COMPREHENSIVE GROUND WATER MONITORING EVALUATION
OF THE
SOUTHERN CALIFORNIA CHEMICAL COMPANY

EPA ID NO. CAD008488025

3 June 1988

Comprehensive Ground Water Monitoring Evaluation
FY 87-88

Figure 3. Ground Water Elevation Map

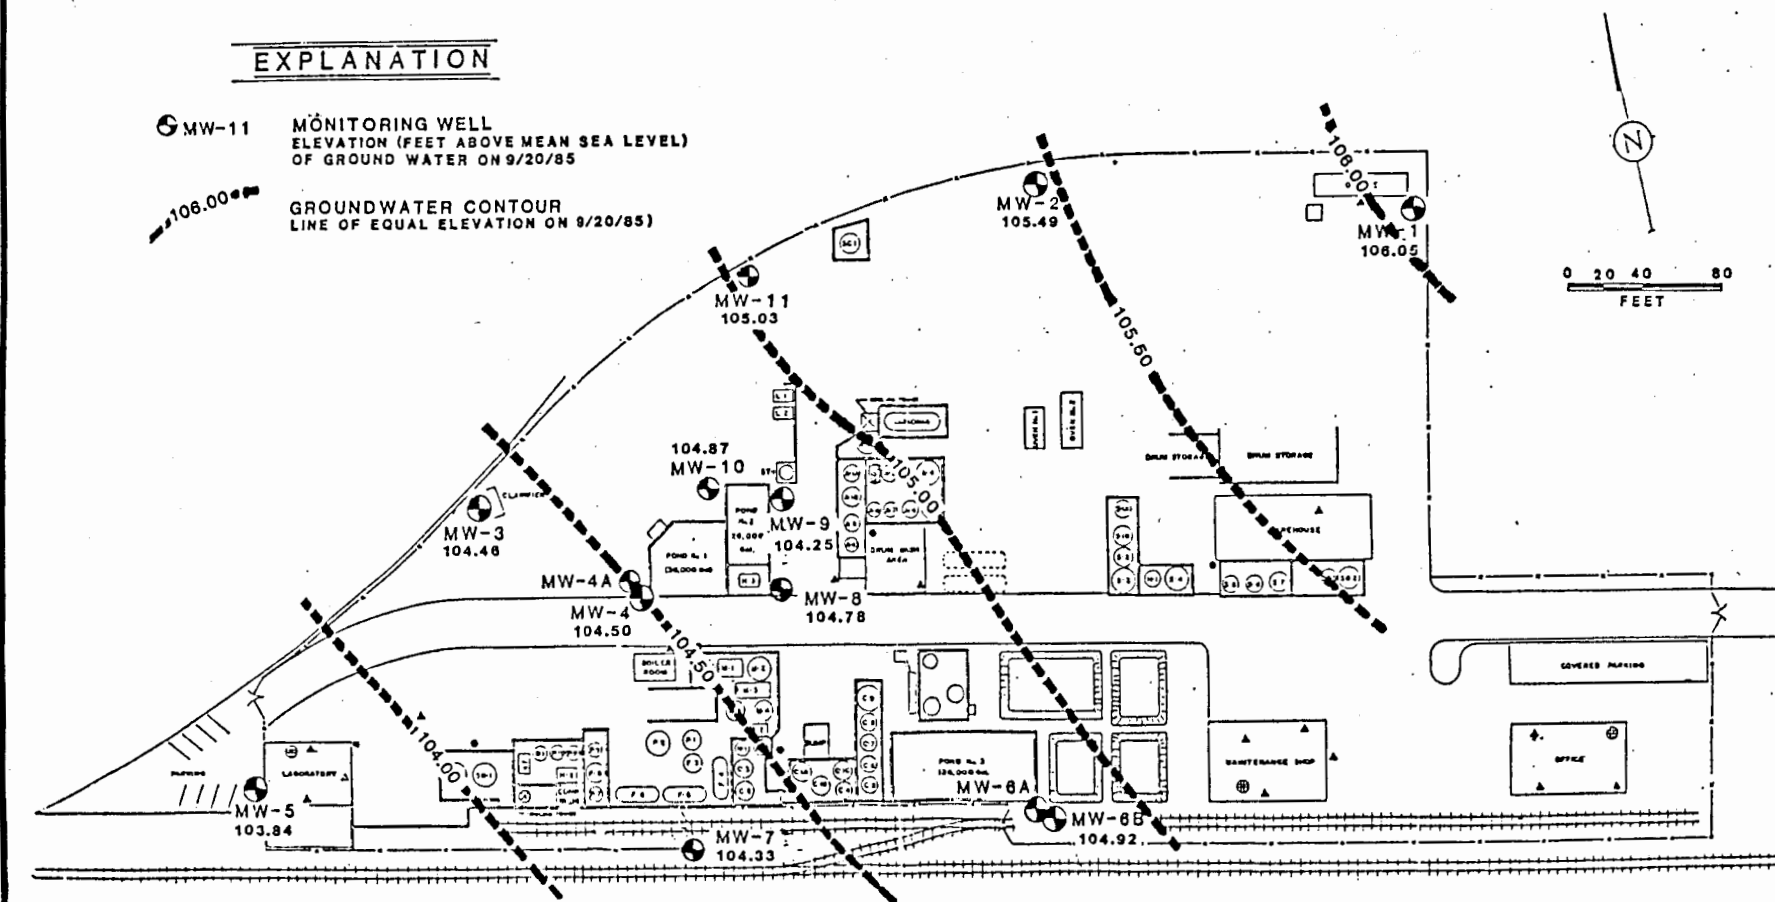
The regional ground water gradient in both the Gage and Hollydale Aquifers is to the southwest. Figure 3 is the most recent ground water elevation map prepared by J. H. Kleinfelder & Associates

[9]. Figure 4 is a ground water elevation map prepared by the CME Task Force. Depth to ground water measurements taken during the visual site inspection and used to generate the Task Force map are included in Table 2. These data tend to confirm that the ground water gradient is toward the southwest.

Figure 5. LOCATIONS OF MONITORING WELLS AT SOUTHERN CALIFORNIA CHEMICAL, INC.

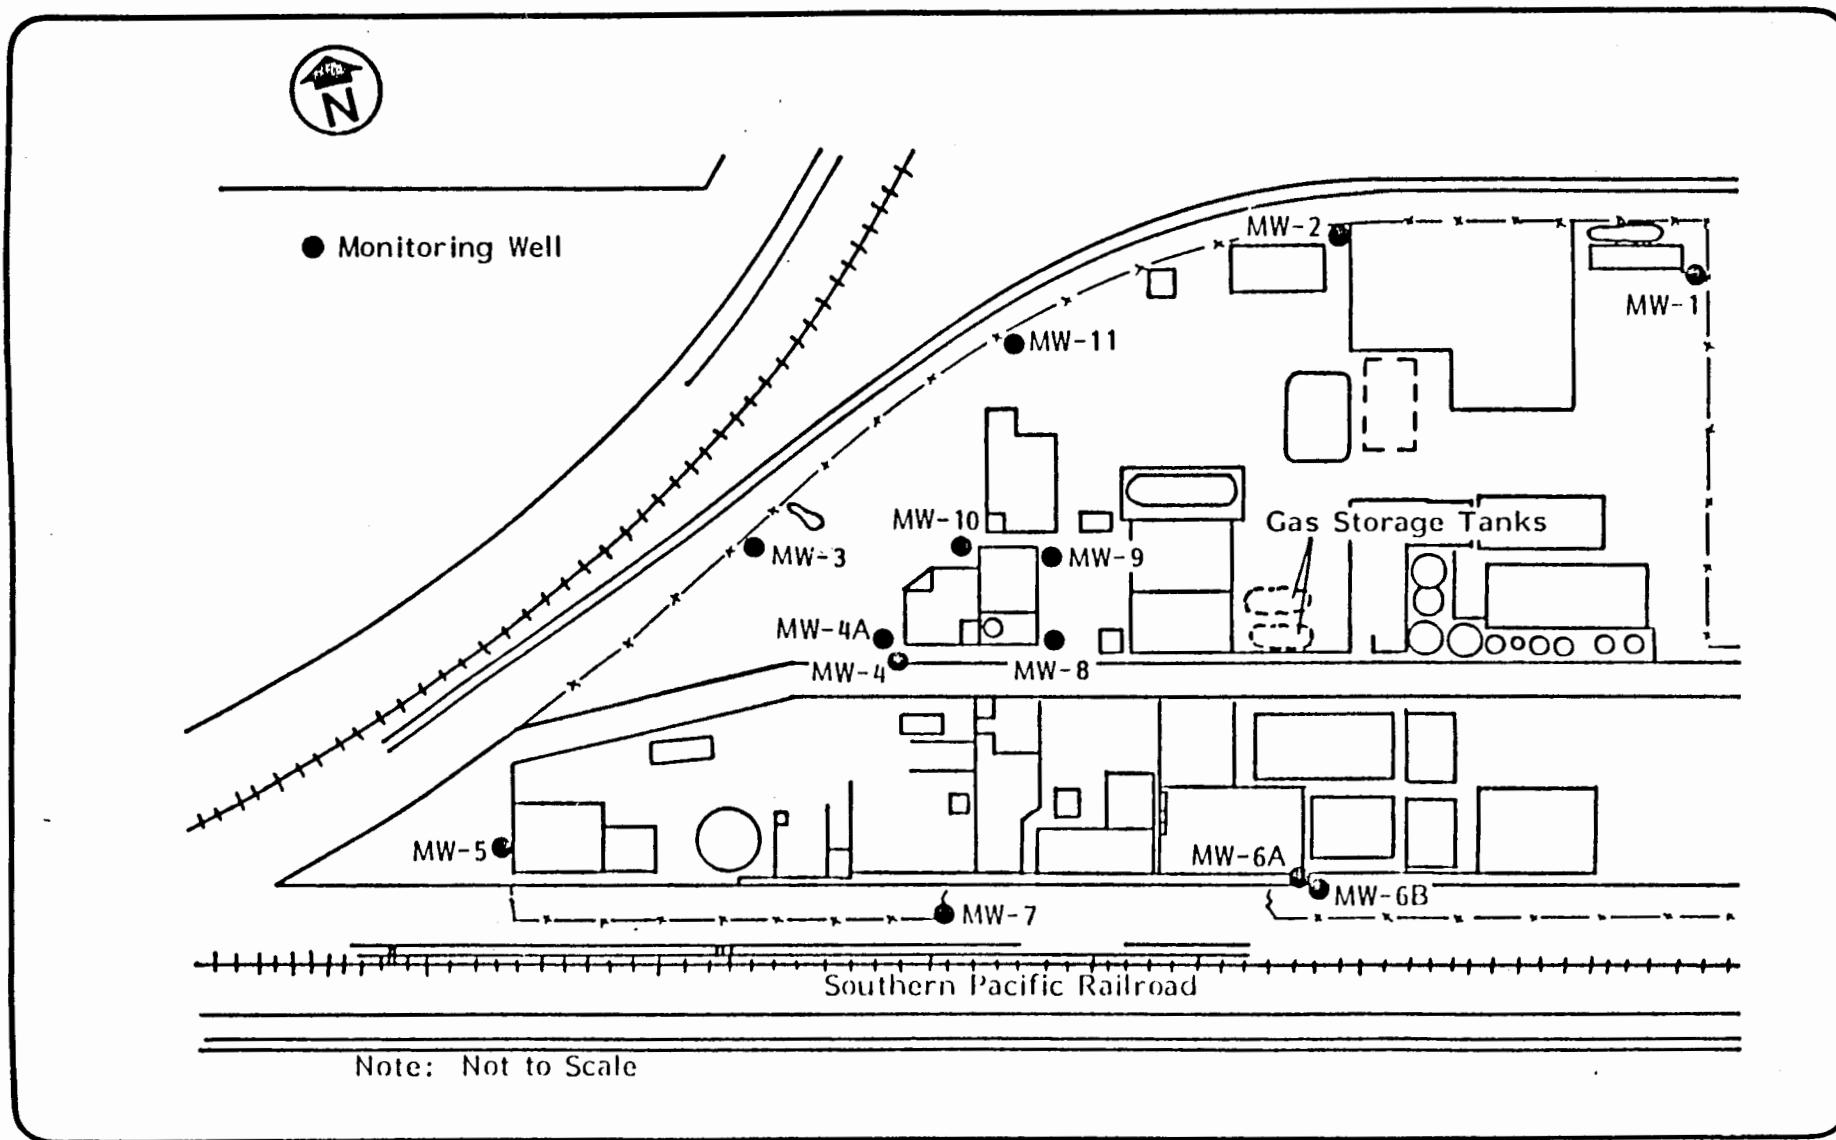
As of this date 13 monitoring wells are in place; however the number, location, and depth of these wells is inadequate to determine the extent of contamination from Pond 1.

Figure 5 shows the locations of the 13 existing ground water monitoring wells.

Figure 6

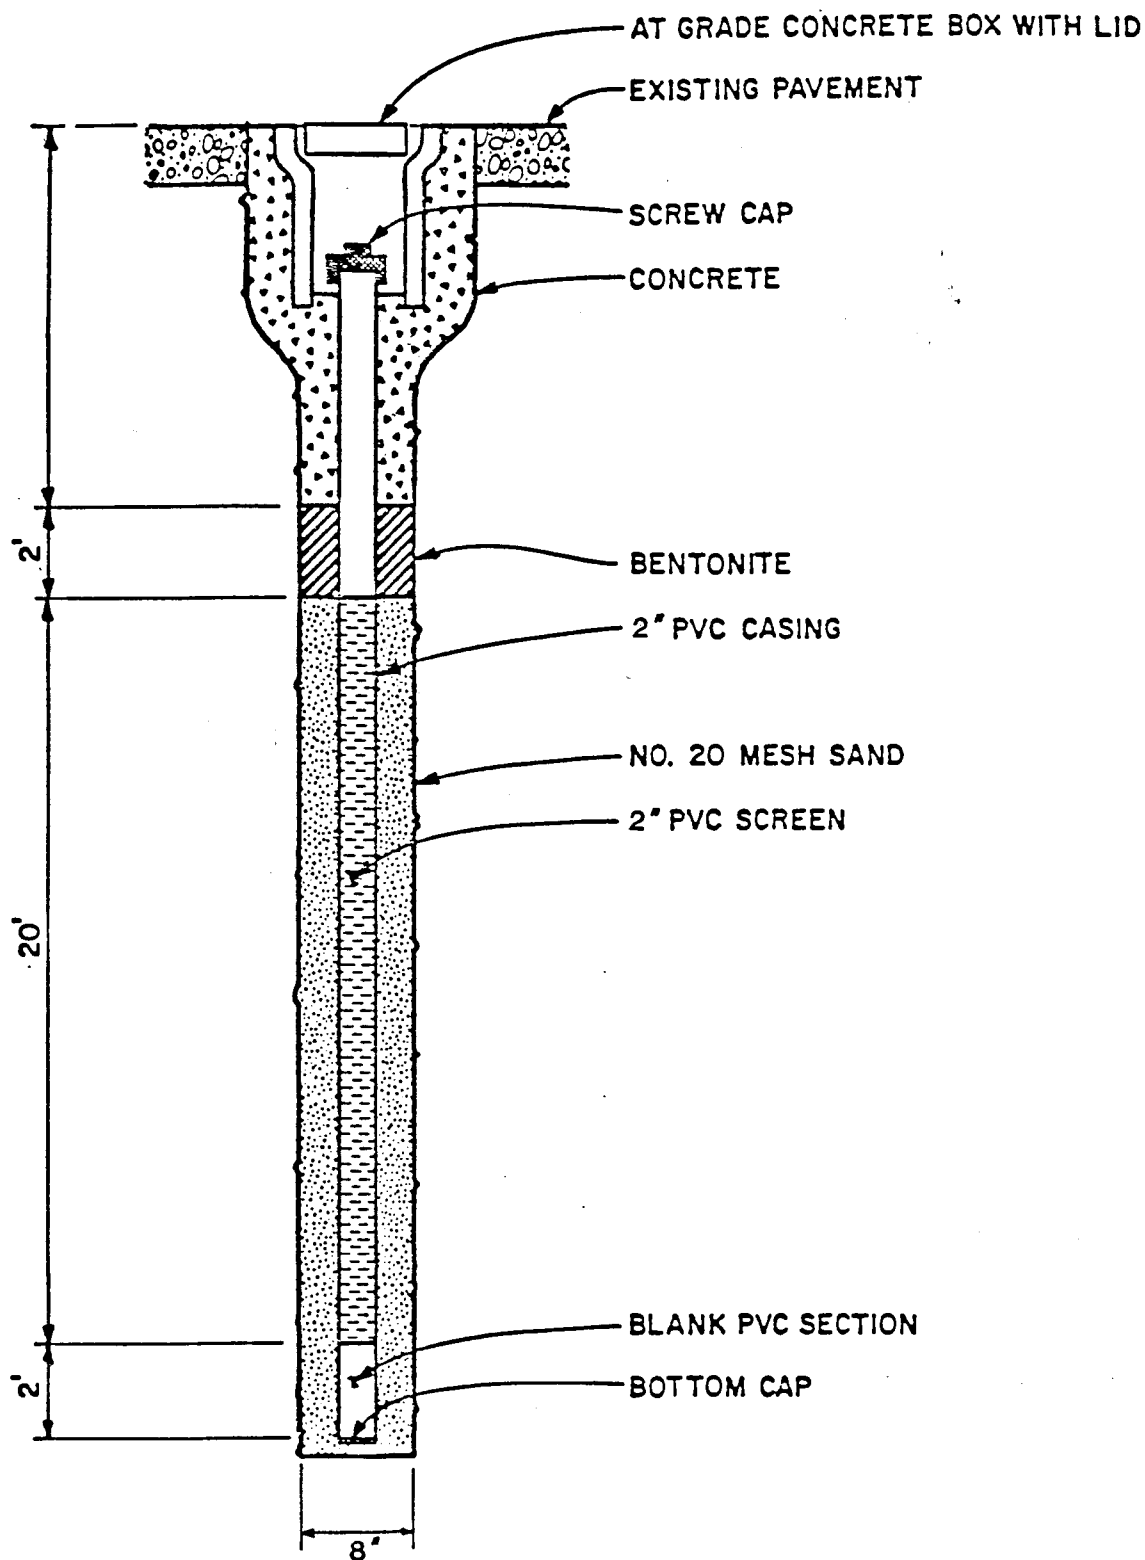
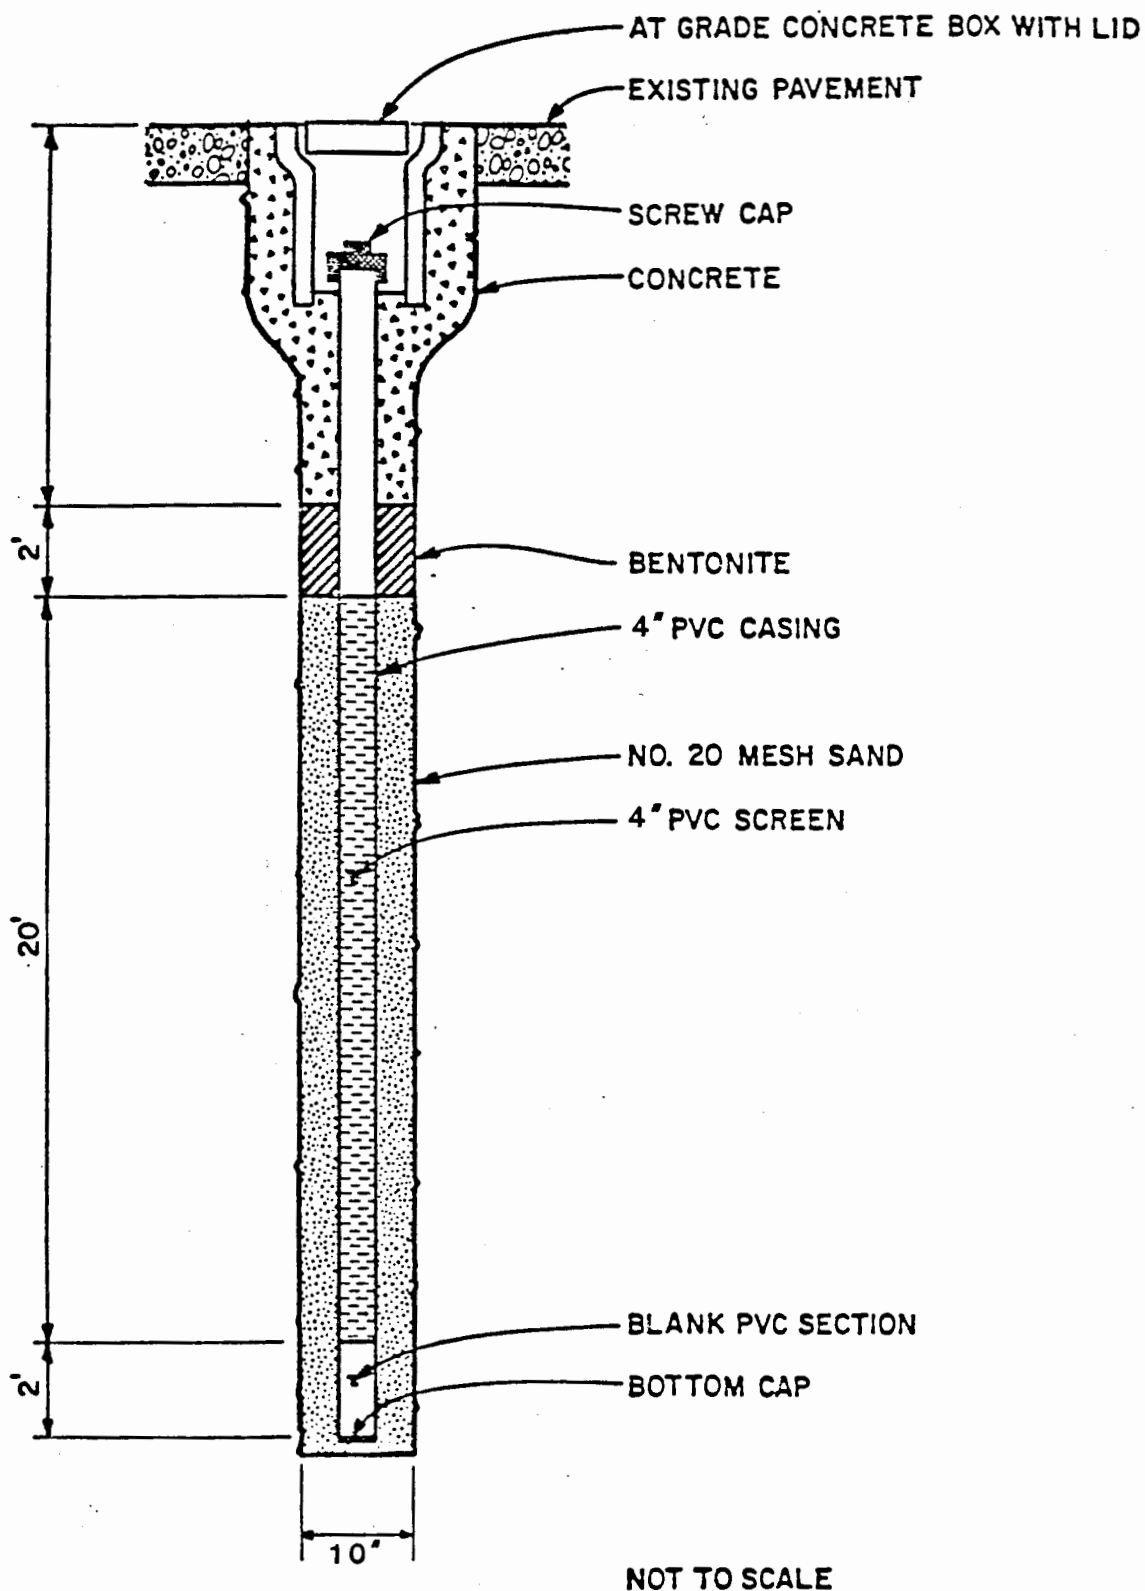
J. H. Kleinfelder & Associates has submitted several different "well configuration" diagrams as examples of how monitoring wells are constructed by the company. Of the 13 ground water monitoring wells, 11 are 2-inch diameter wells (Figure 6) and two are 4-inch diameter wells (Figure 7). However, the original drill logs indicate that none of the wells were constructed according to the "typical" well construction diagram, as explained below:

1. Two feet of "blank PVC section", a sediment trap, was not used at the bottom of each well.
2. Two of the 2-inch diameter wells were not constructed in an 8-inch borehole (MW-1 and MW-8).
3. Neither of the two 4-inch diameter wells were constructed in a 10-inch borehole (MW-4A and MW-9).

Southern California Chemical Company
Total Chromium Concentration in Well #4

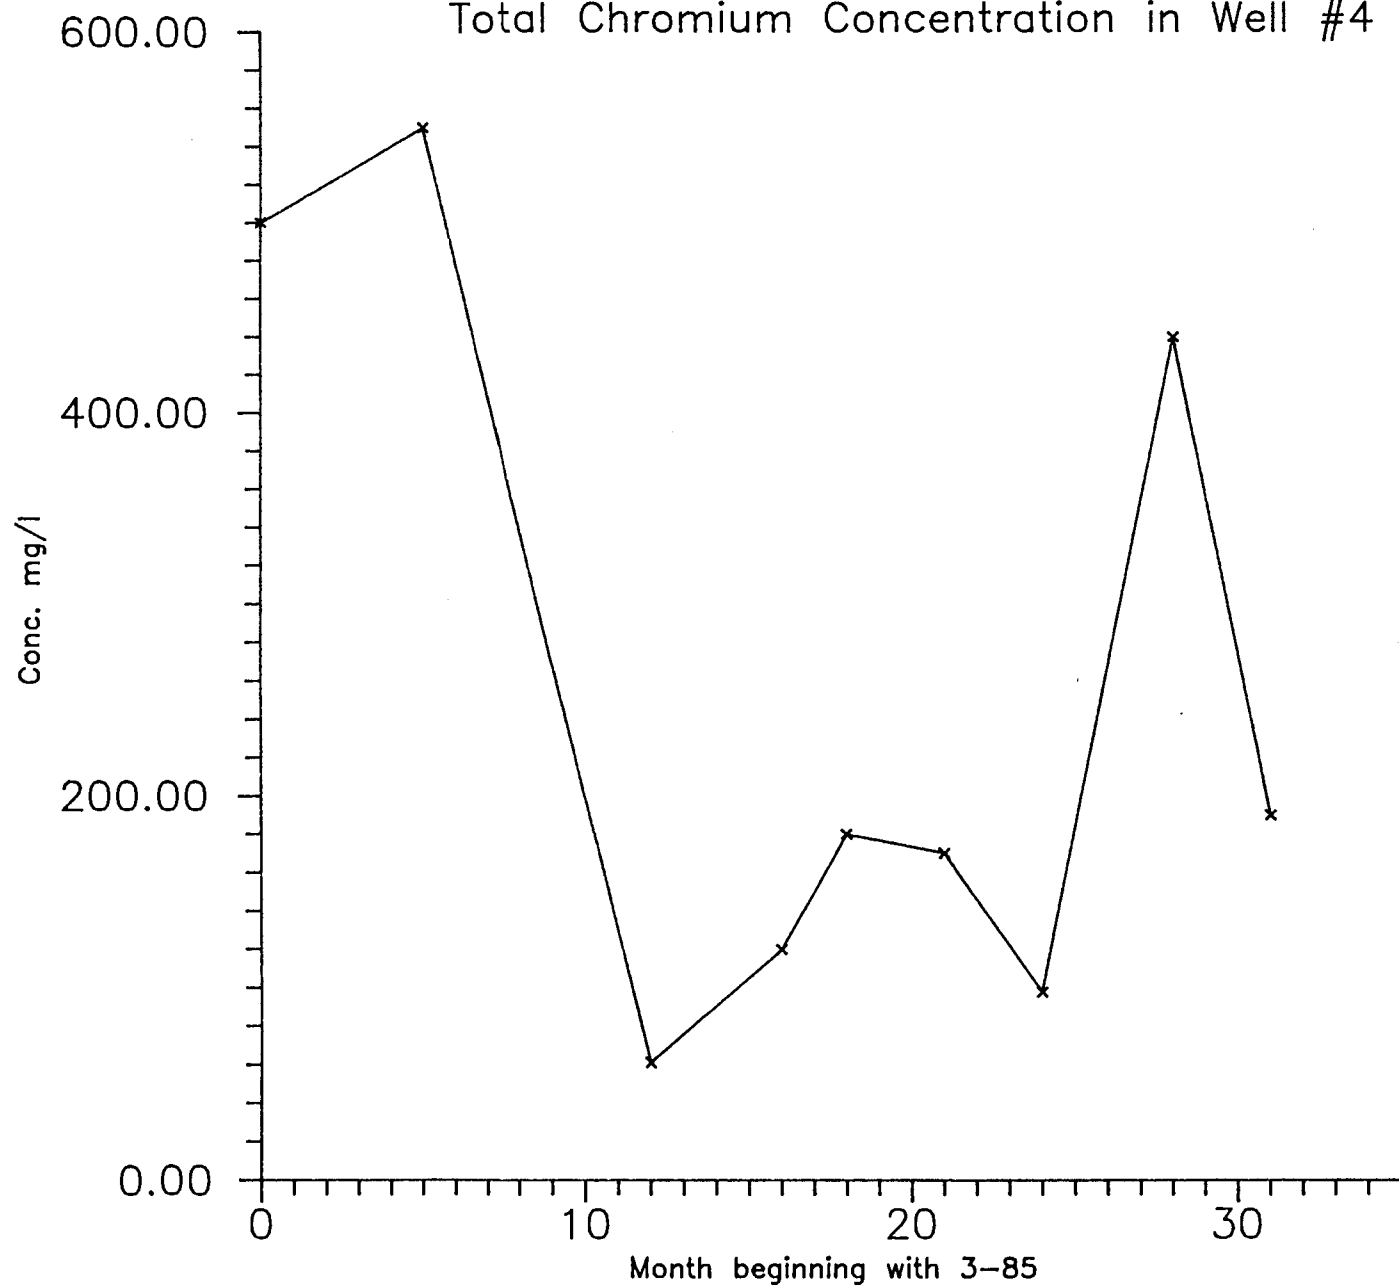
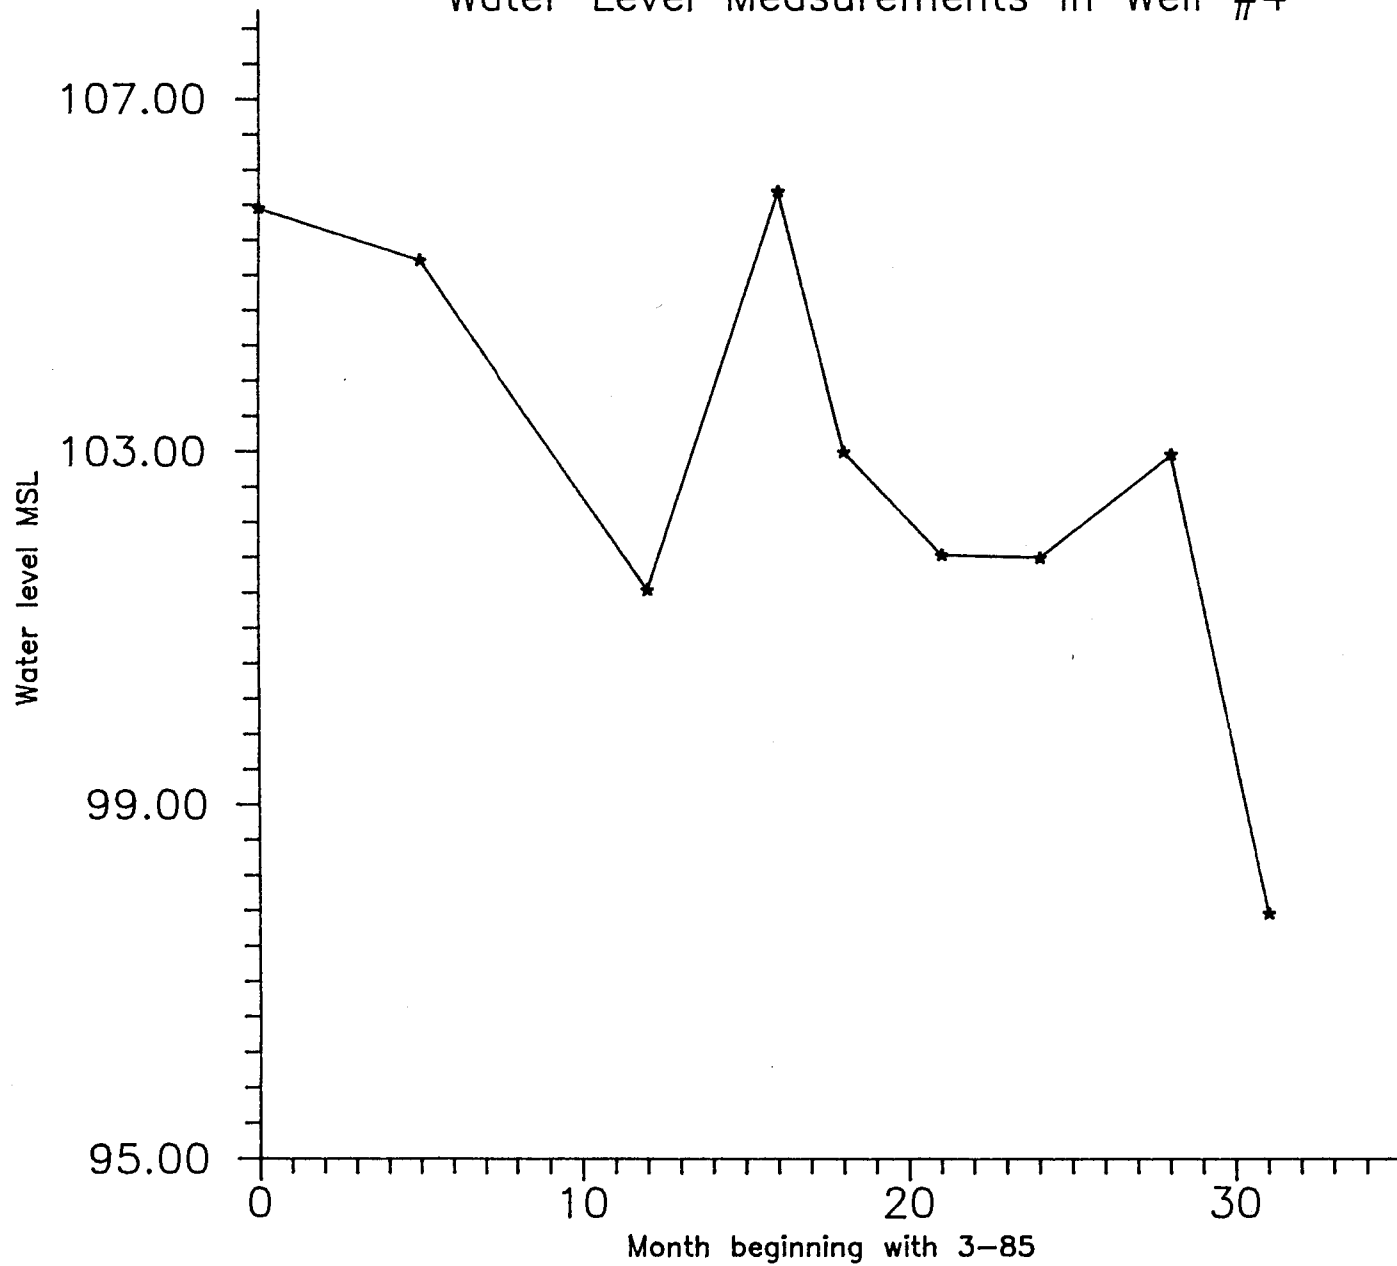
Elevated levels of hexavalent chromium have been detected in MW-4 and MW-9. In MW-4, chromium was originally detected at 500 mg/L; since that time (March 1985), the levels have fluctuated between 61 mg/L and 550 mg/L. The most recent analysis (October 1987) detected 190 mg/L. Figure 8 shows how the chromium contamination in MW-4 has changed with time. Figure 9 shows the fluctuations in water levels beneath the facility. A comparison of these seems to indicate that the concentration fluctuates with the ground water levels.

Even though MW-4 is immediately downgradient of Pond 1, the owner/operator claims that the source of chromium contamination is from an underground tank that was removed some time in the past. The underground tank was supposed to have been in an area slightly upgradient from Pond 1. However, the owner/operator has been unable to provide any evidence that this tank existed.
